PCN # ESW490-49 - Schottky Barrier Rectifier DSTxxx TO-277B Packing Product Reel Change

Littelfuse would like to notify you that we will replace Carboard reel with ESD plastic reel for Schottky Barrier Rectifier DSTxxx TO-277B packing Products.

1.0 Physical Difference:

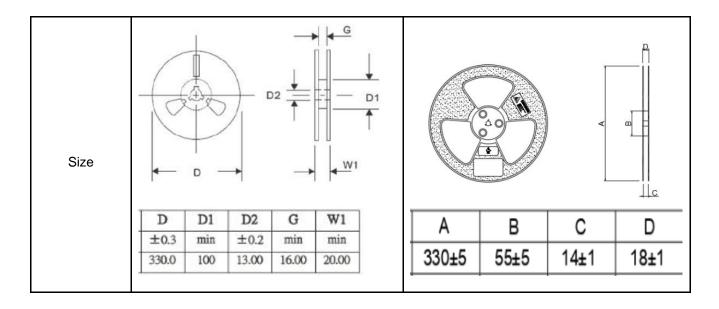
Туре	Current	New
Appearance		
Material	Carboard	PS
Color	White Reel	Bule Reel
